Decision Table G. Willamette River - Environment

MEMO

SUBJECT: **Attachment for Decision Table G: Willamette River - Environment**

This memorandum contains BPS staff-recommended revisions to portions of Zoning Code sections 33.475 and 33.430 in the Proposed Draft Central City 2035 Plan. Specific changes include the following items described in Decision Packet G:

**Figure 475-3
Landscaping Area**

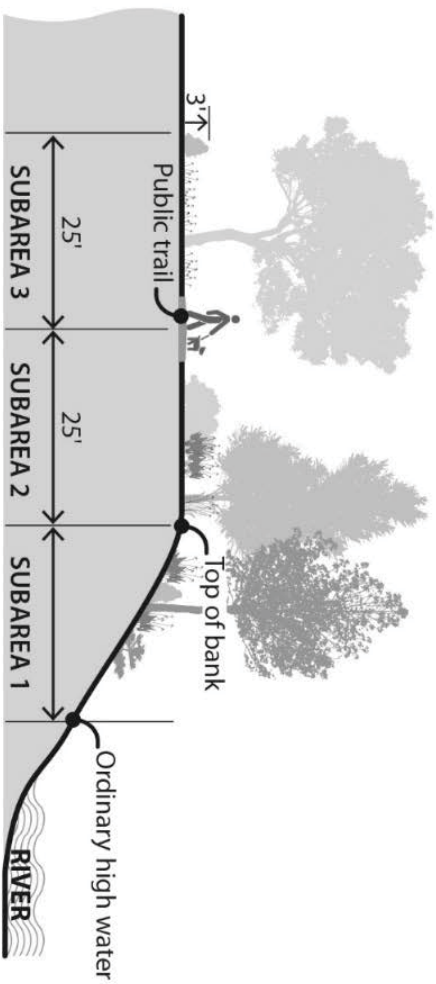
G1 – River Setback Landscaping Standards

1. Governor Tom McCall Waterfront Park **and the Eastbank Crescent**, shown on Map 475-3, are exempt from this Section.
2. Required landscaping for all other areas. For all other areas, land within and riverward of the river setback that is not covered with a building or other structure or developed with a trail or viewing area must be landscaped to meet Table 475-1, Landscaping Planting Density. Subareas are shown on Figure 475-3 and described below. There are three planting densities allowed within each subarea. The applicant may choose which planting density standard to apply within each subarea, and more than one planting density may occur on a site. For example, the applicant may choose planting density 1 for all the subareas, or planting density 2 for subarea 1, planting density 3 for subarea 2, and planting density 1 for subarea 3.

- a. Subarea 1 extends from the ordinary high watermark to the top of bank of the Willamette River.
 - b. Subarea 2 extends from the top of bank to a point 25 feet landward of the top of bank of the Willamette River.

- c. Subarea 3 extends from a point 25 feet landward of the top of bank and a point 50 feet landward of the top of bank of the Willamette River.

- d. Vegetation planted to meet the resource enhancement standards of 33.475.440.G, the mitigation standards of 33.475.440.K or the clean-up of contaminated sites requirements of 33.475.500 may be counted towards meeting the landscaping standard.
